LJA ENGINEERING

Master Utilities Report

Jamaso

Aurora, Colorado

SANITARY SEWER SYSTEM MAP

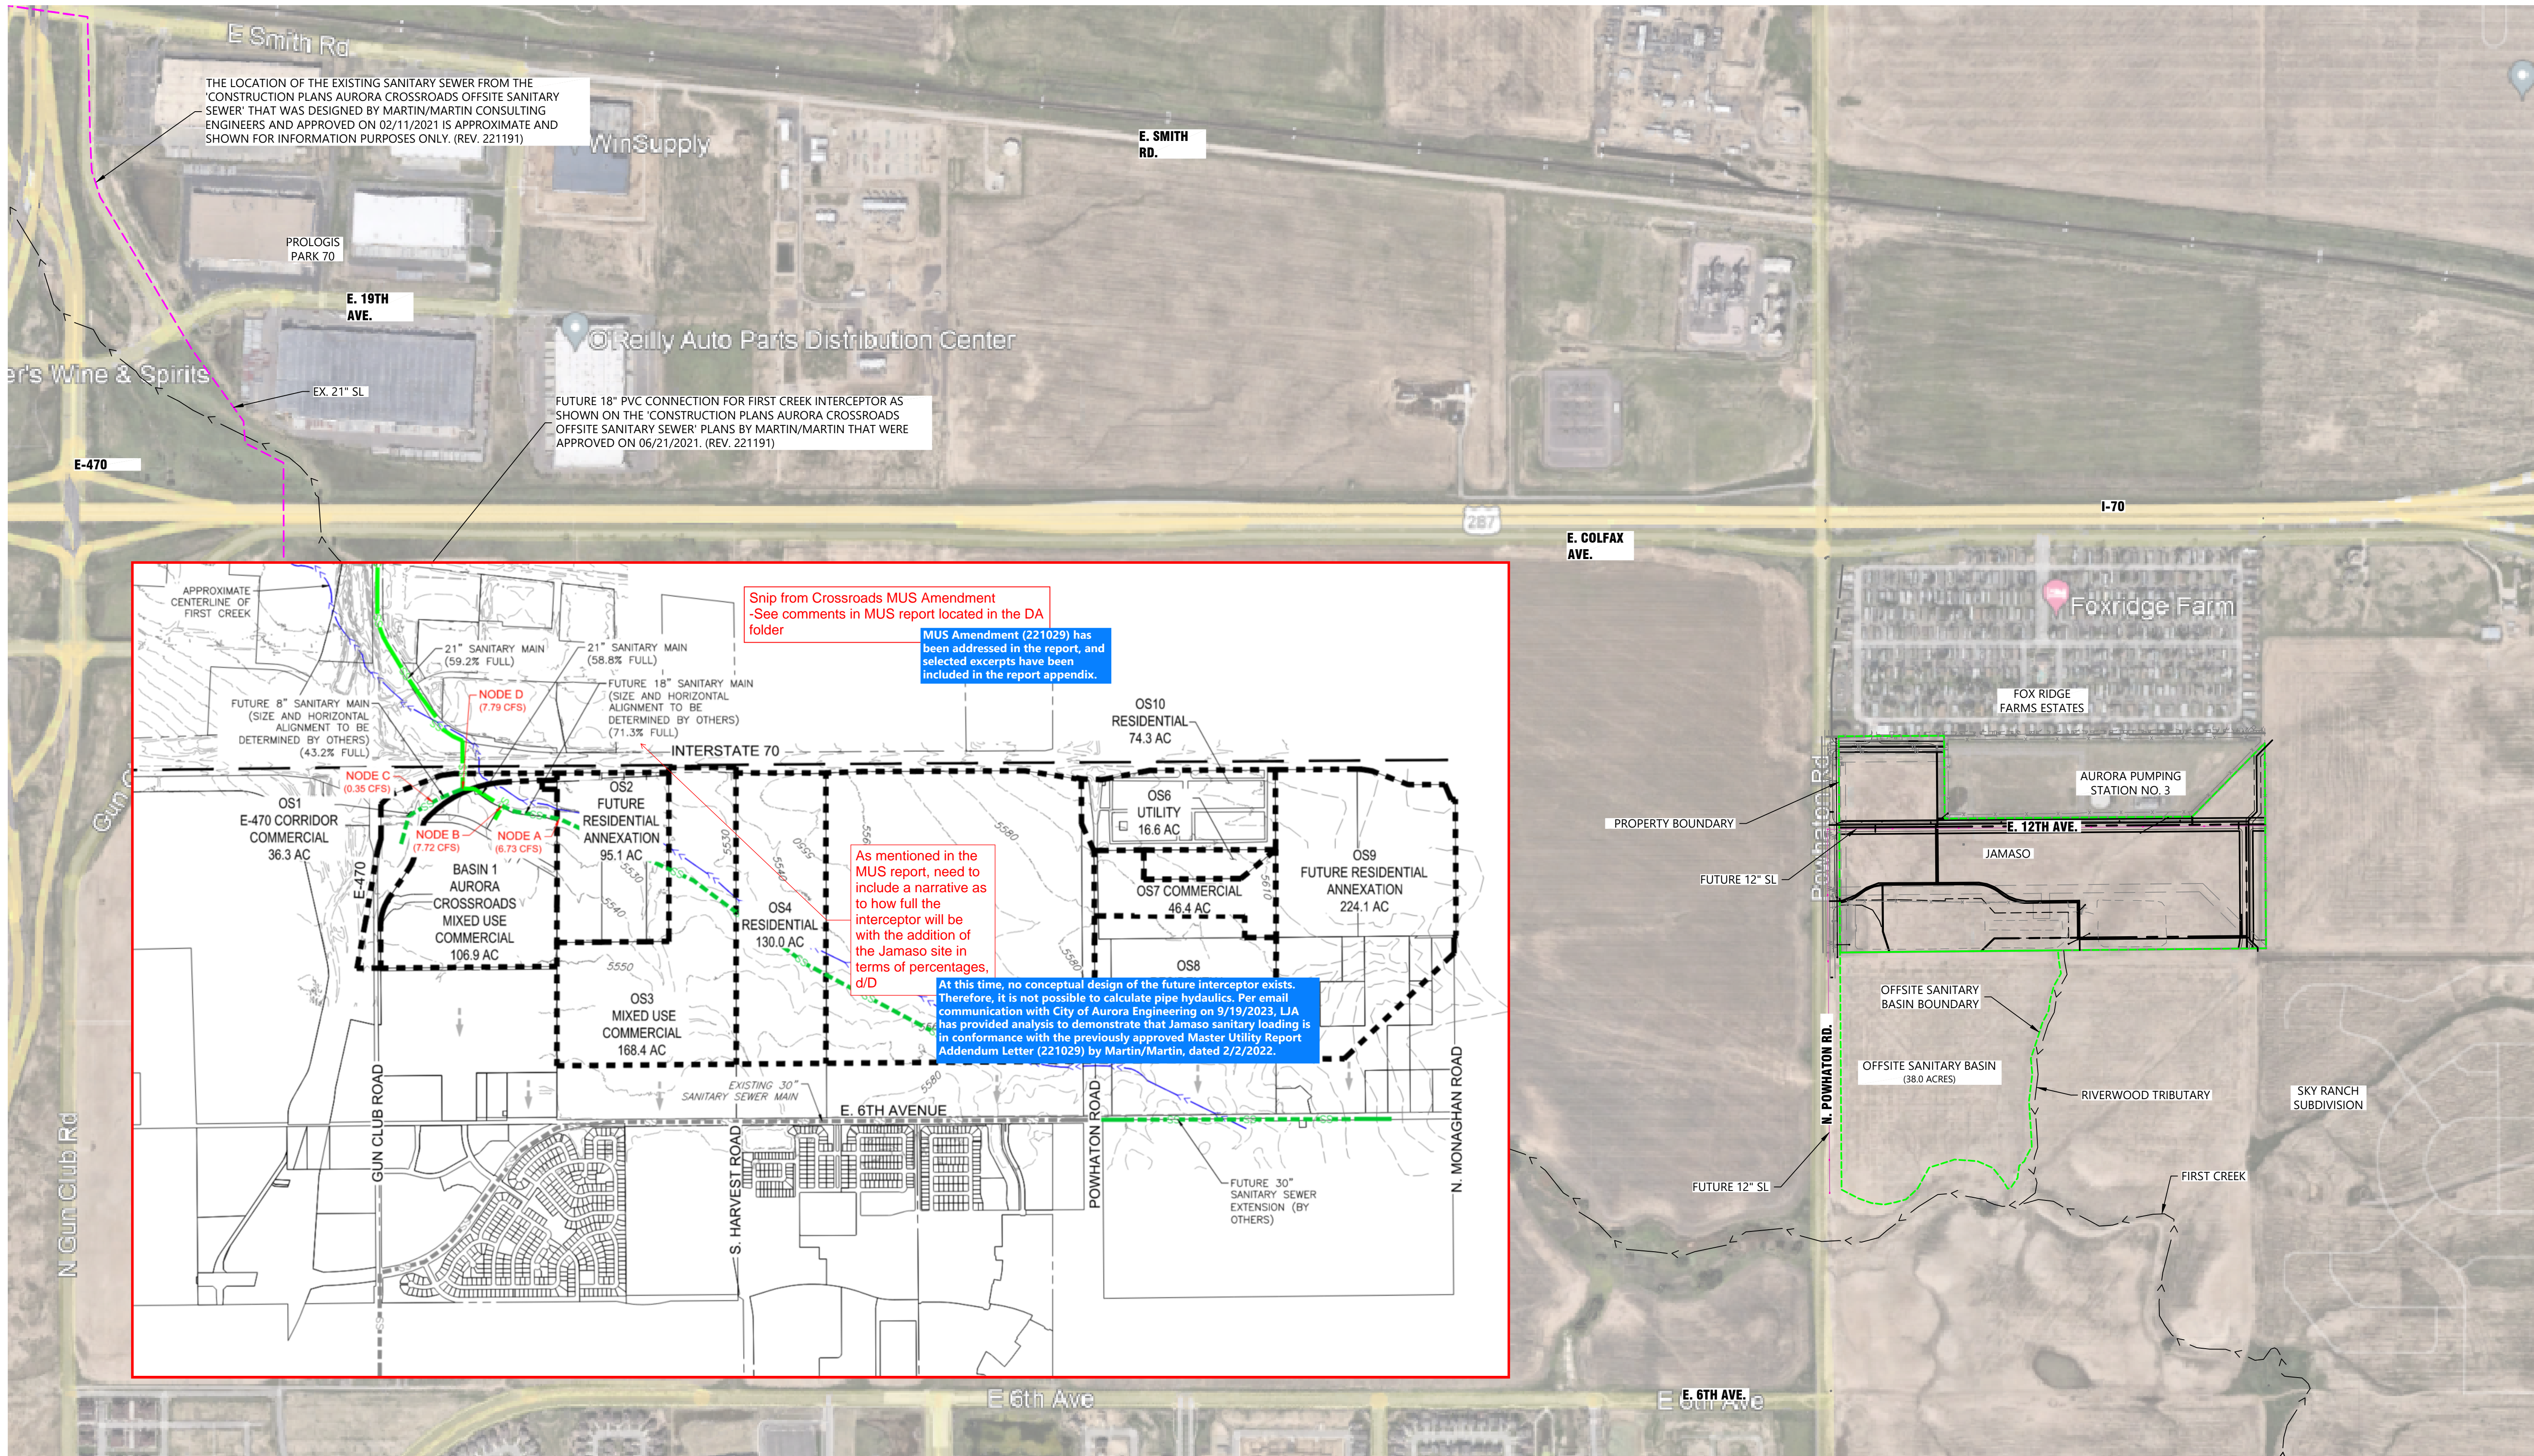
Appears that the MUS report was not included with this submittal- Include

Master Utility Study Addendum (EDN 221029, Feb. 22, 2022, by Martin/Martin) has been addressed in the report, and excerpts have been included in the report appendices. The MUS Addendum does not significantly impact the proposed sanitary sewer design. There are no significant updates to this drawing.

WATER DISTRIBUTION MAP

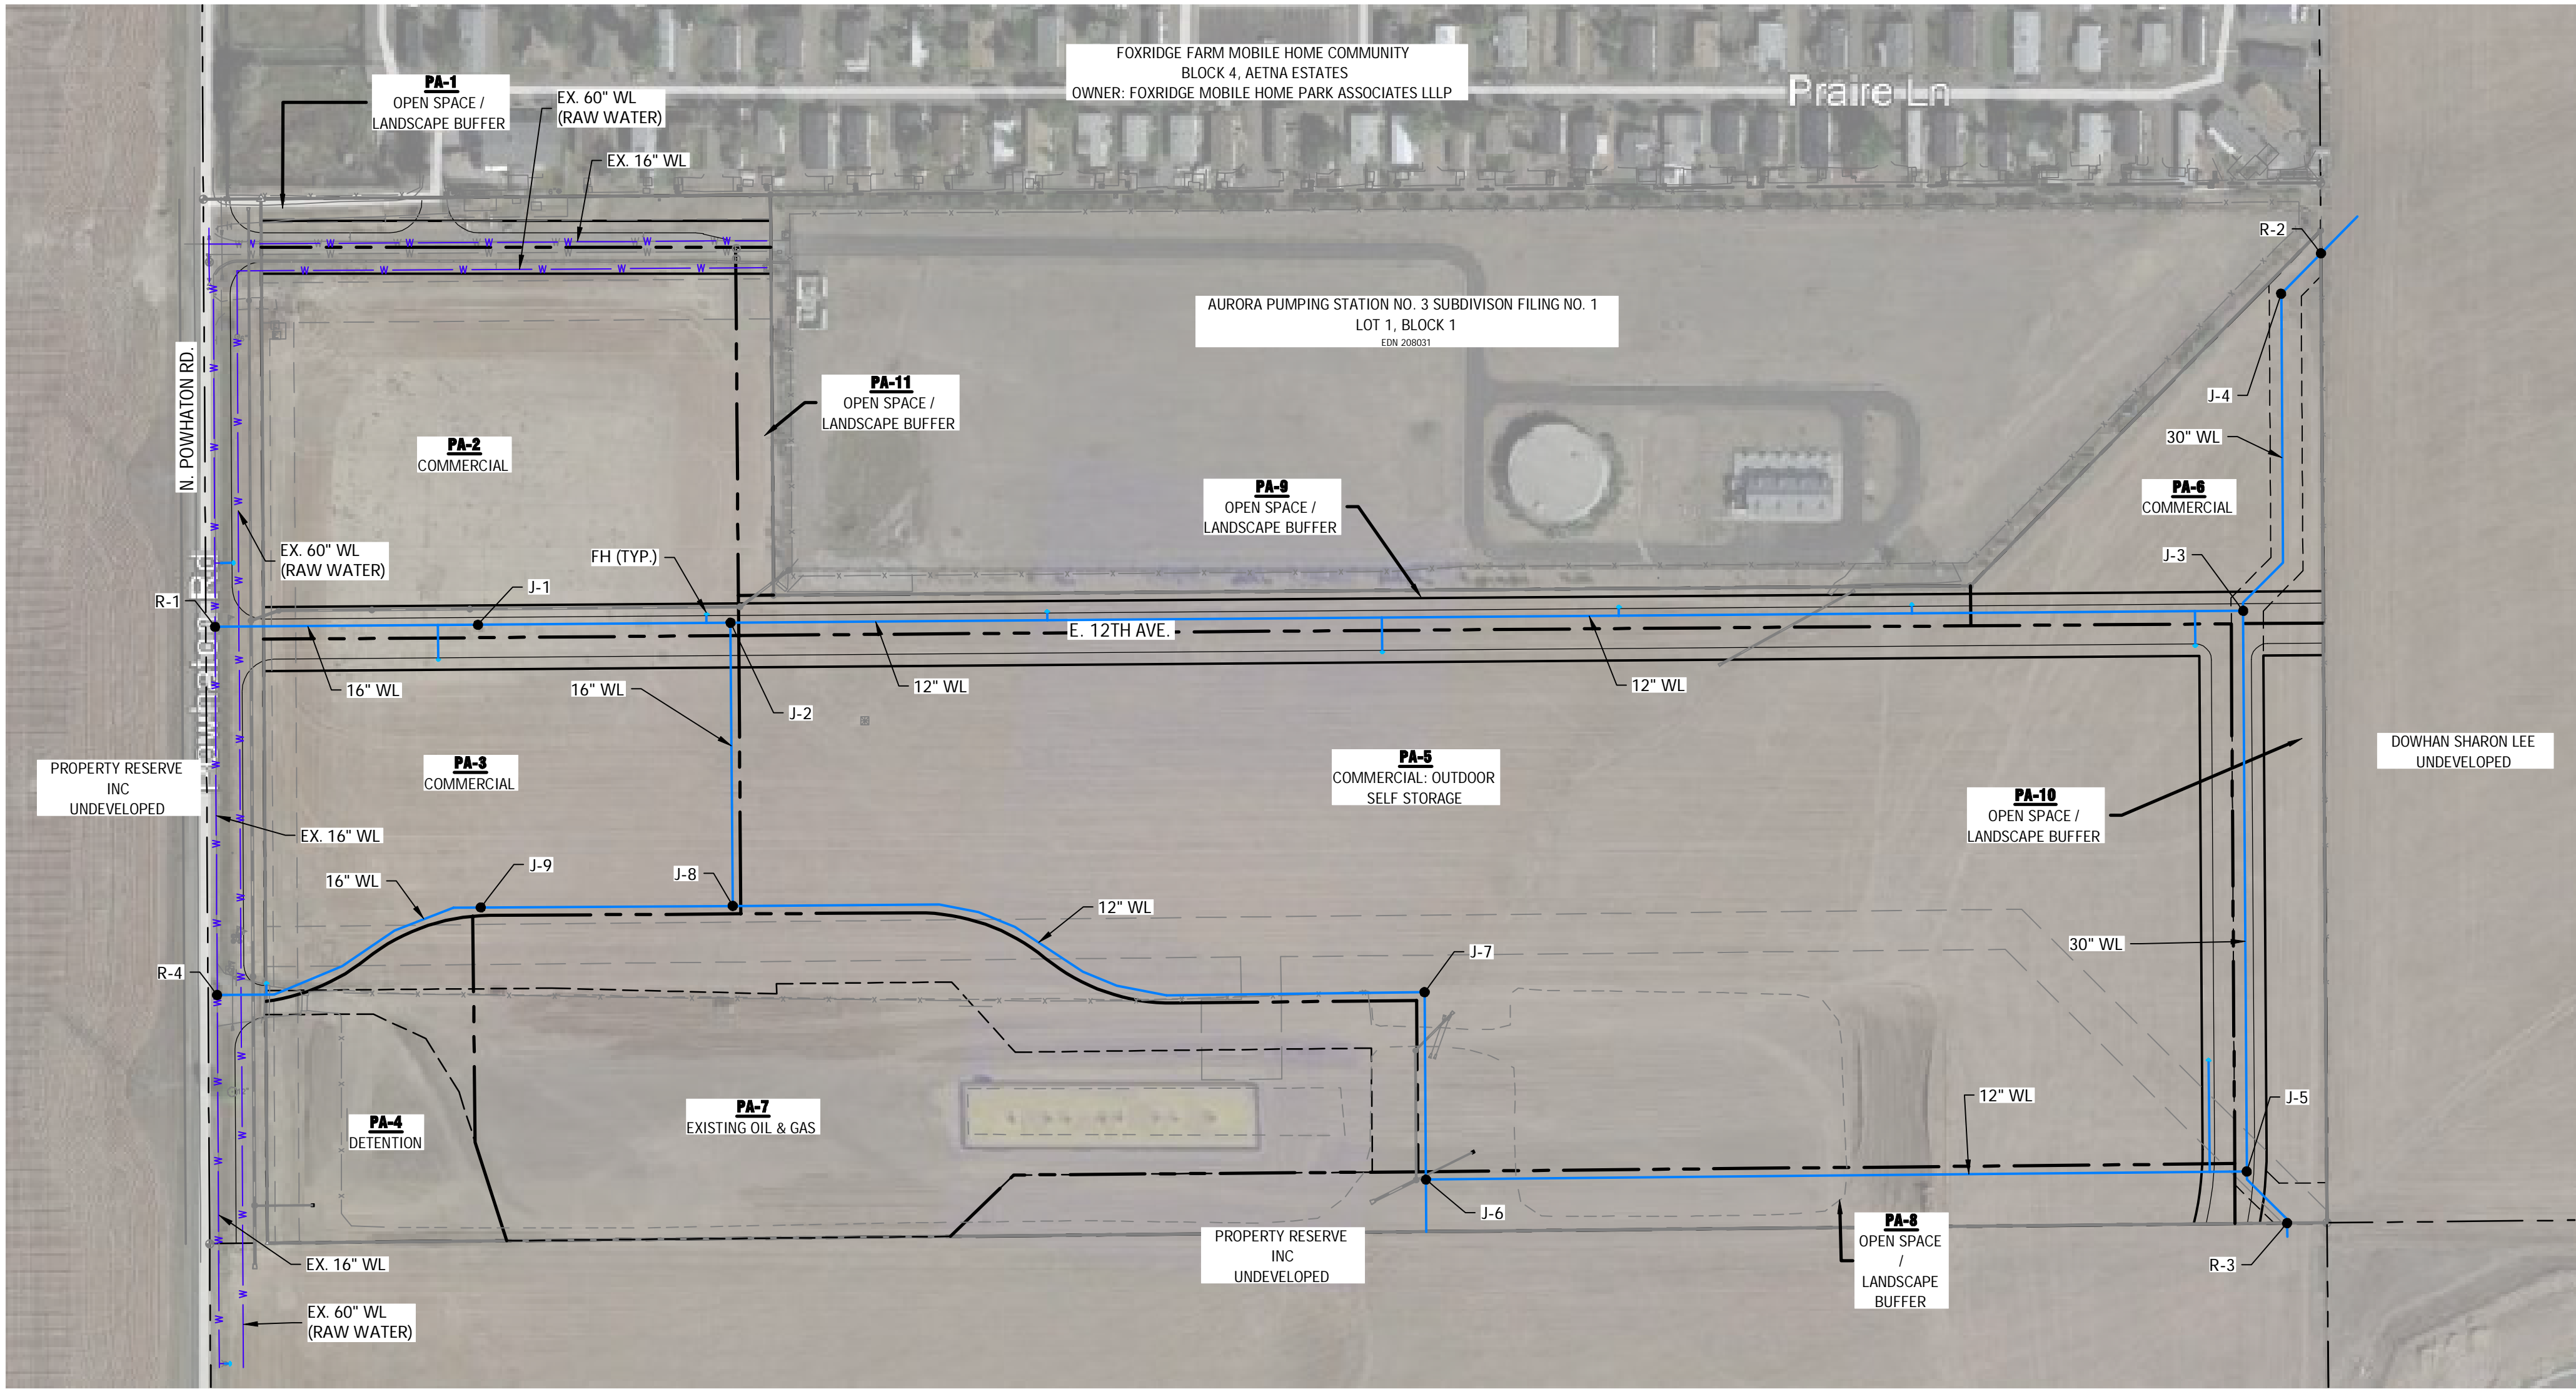
Appears that the MUS report was not included with this submittal- Include

City engineer signature line no longer required

Master Utility Study Addendum (EDN 221029, Feb. 22, 2022, by Martin/Martin) has been addressed in the report, and excerpts have been included in the report appendices. The MUS Addendum affects sanitary sewer but not WL design. There are no significant updates to this drawing.

Approval block has been updated - "City Engineer" signature line has been removed.
